**Item 4.****Development Application: 5-19 Mary Street, Surry Hills - D/2022/1343**

File No.: D/2022/1343

**Summary****Date of Submission:** 22 December 2022

Figure 43: Applicant's overshadowing documentation illustrating solar impact to studio units located on level 4 of 56-60 Foster Street

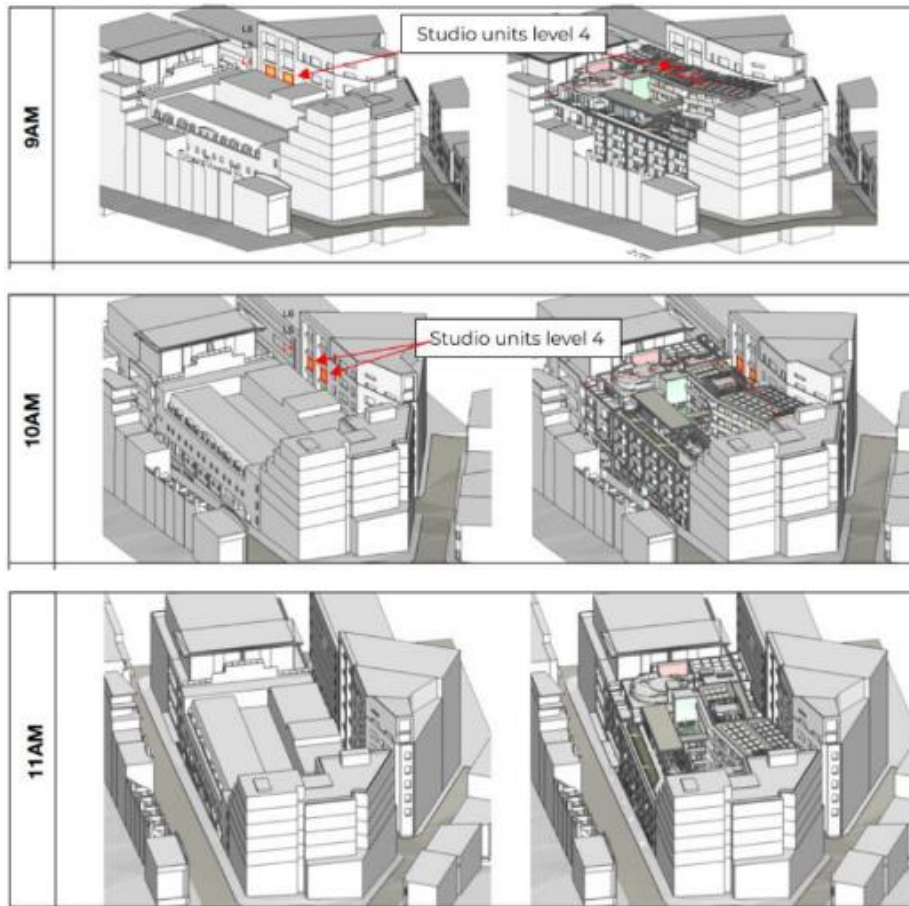
78. The applicant's solar documentation illustrates that these units will be impacted by the proposed development at 9am and 10am at midwinter (21 June). The impact is illustrated in Figure 43 below.

79. Notwithstanding, unit 42 and unit 43 currently do not receive 2 hours of direct solar access to the living areas on 21 June. The windows receive between 15 minutes and 2 hours of solar access between 9am-11am, before returning to shade for the remainder of the day. The diagrams conclude that the proposal would not result in any further decrease in the number of apartments which did not receive 2 hours of solar access. Therefore, the proposal complies with the City of Sydney Draft Minimising Overshadowing of Adjoining Development Guide, as it would not result in any further decrease in the number of apartments which did not receive 2 hours of solar access.

Figure 46: Applicant's overshadowing documentation illustrating solar impact to 46-54 Foster Street

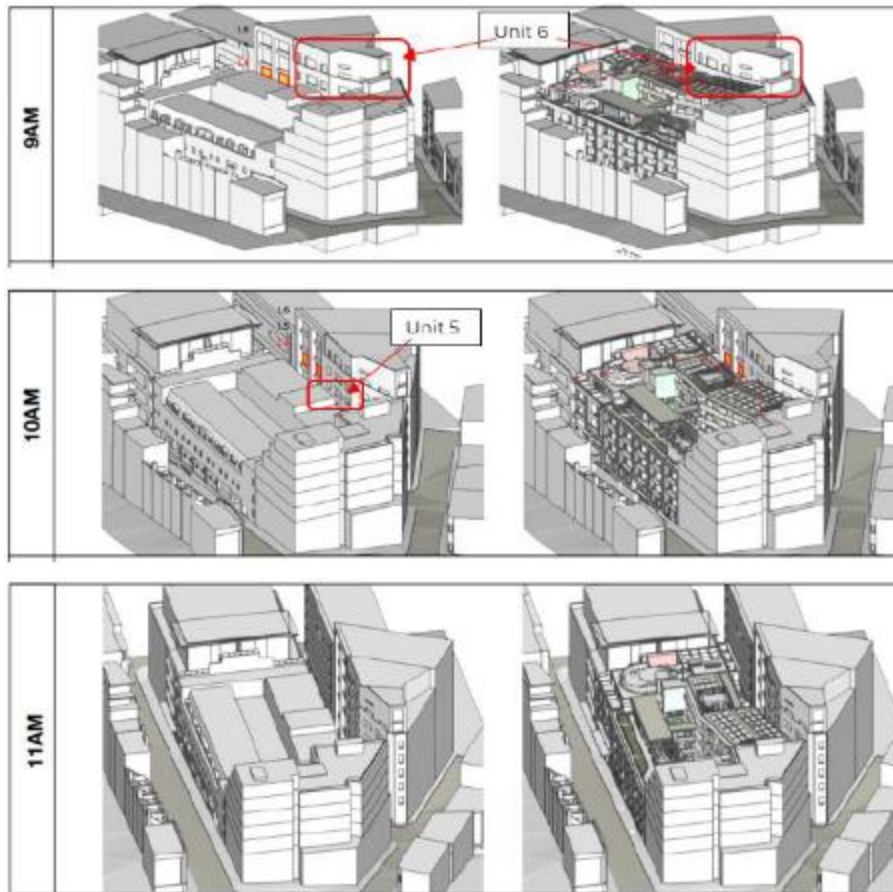
- 84. The applicant's solar documentation illustrates that Level 5 and 6 will be impacted at 9am and 10am on 21 June. The impact is illustrated in Figure 46 below.

85. Notwithstanding the above, the solar access requirements of the Apartment Design Guide (ADG) refer to solar impacts to living room windows and areas of open space. As demonstrated in the floor plan above, the layout of the impacted units is designed with bedroom and kitchen windows to the Hands Lane frontage of the site, with the main living areas orientated to Foster Street. Therefore, compliance with ADG is achieved.
86. It is noted that objections were raised from occupants on other levels of the building in relation to overshadowing. All other units in the building either are not impacted from the development (i.e. already shadowed by existing built form at midwinter), and/or have living room windows on the Foster Street frontage of the site and therefore would receive in excess of 2 hours of solar access from 11am at midwinter.

**Figure 47:** Hands Lane elevation illustrating privacy screening to residential balconies within the mixed-use site

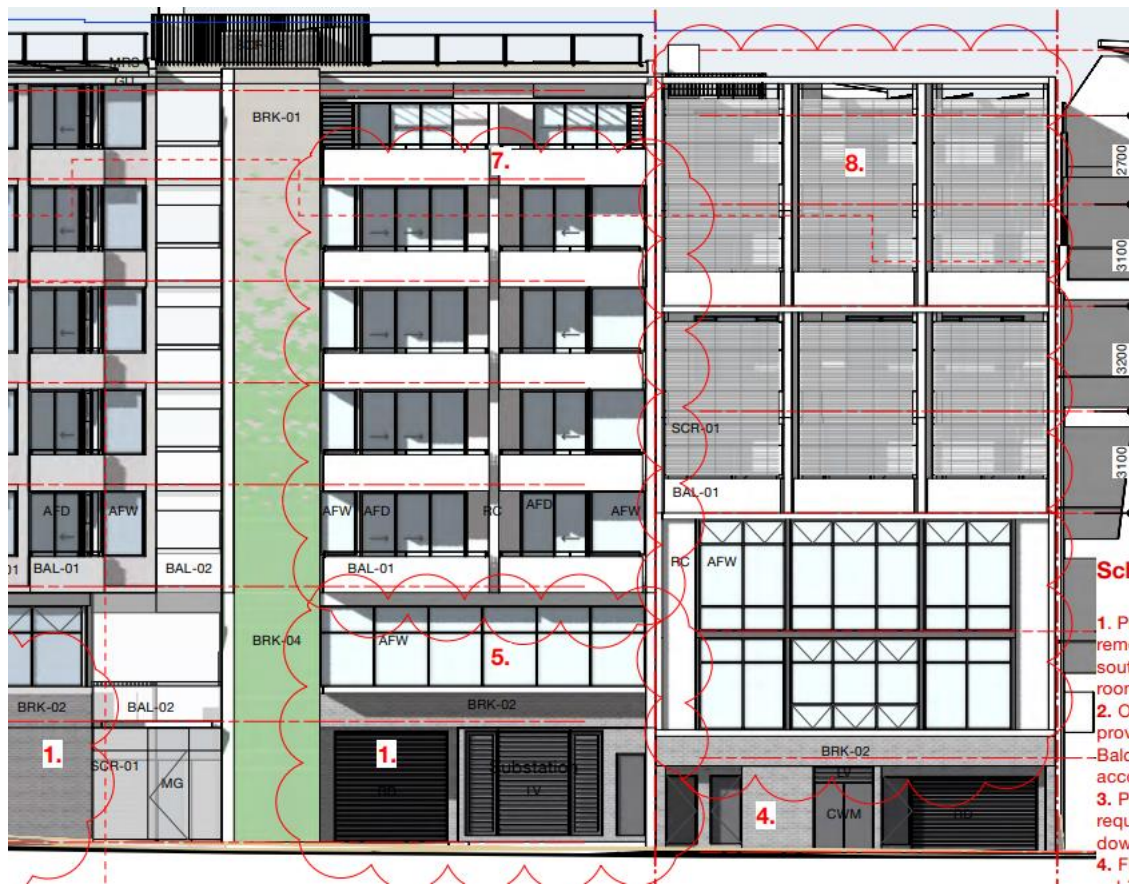
108. The balconies within the Foster House do not offer privacy screening, but are generally angled away from 56-60 Foster Street, across 46-54 Foster Street. These balconies are proposed with solid concrete balustrades and offer minimal space offering limited usage. Potential privacy implications from these balconies is not considered to be out of character within a dense urban environment.

109. Given the layout and constraints of the subject site, the angle of Hands Lane and the design features proposed including angled walls and screening, the proposal will maintain reasonable visual privacy despite not strictly meeting the 12m separation distance. The design has appropriately considered uses opposite Hands Lane and provides an appropriate design response. The design and nil setback is similar to that of other residential properties in the area and would not be considered out of context with many other residential developments in the Surry Hills area.

**Figure 49:** Illustrating proposed 300mm balcony projections onto Hands Lane

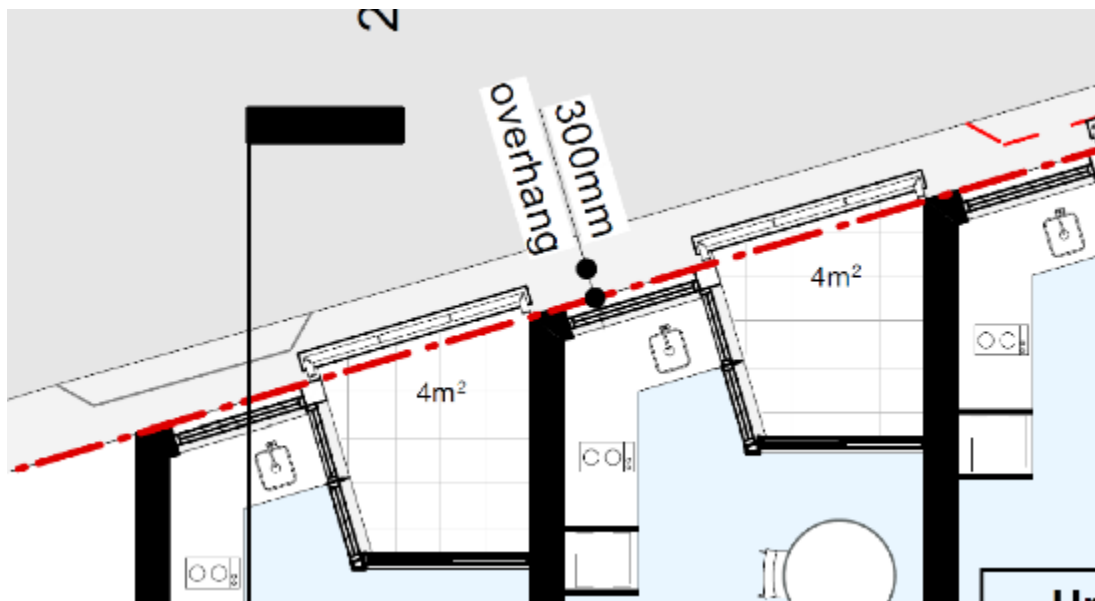
110. During the course of the assessment, the application has been amended to remove balcony projections onto Hands Lane. At the request of Council staff, balcony projections were removed for the mixed-use site and some balconies within Foster House, as illustrated in Figure 48 below. The applicant has retained a 300mm projection on Hands Lane for the co-living balconies.

113. With consideration to the above, the projections are acceptable in this instance.

**Figure 51:** Illustrating air flow throughout the mixed-use site

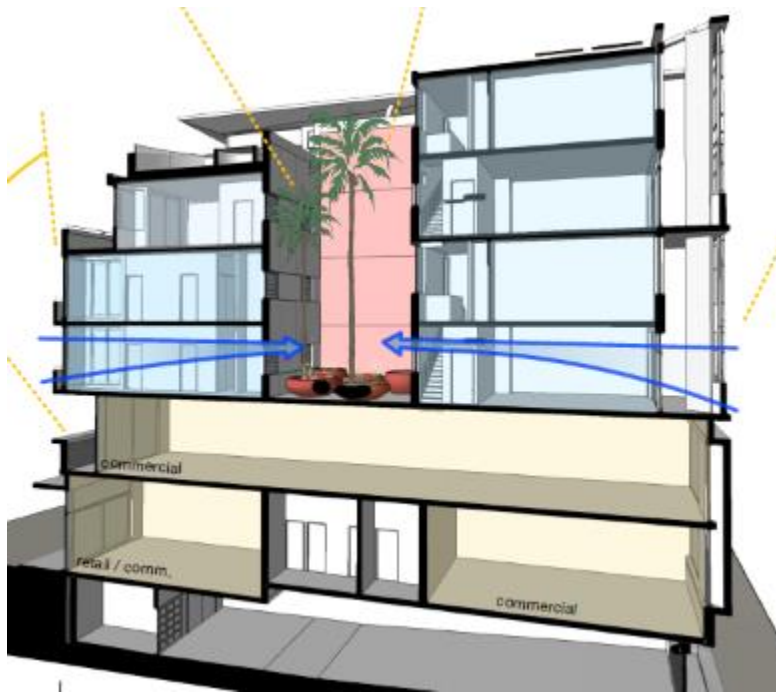
115. Cross ventilation is counted by the applicant as achieving 100%. However, the apartments rely on openings into a common courtyard where all surfaces are hard and will rebound noise through the courtyard into apartments. Cross ventilation is illustrated in Figure 51 below.

117. It is noted that in the two storey apartments, the windows into the courtyard are secondary windows and not primary windows for habitable rooms, offering a degree of separation and mitigates acoustic privacy impacts. However, single aspect apartments (unit 3, 5, and 9), rely on windows to habitable spaces.

118. Notwithstanding, when discounting the single aspect apartments (Unit 3, 5, and 9) the overall cross ventilation remains compliant at 62.5% and therefore complies with the ADG.
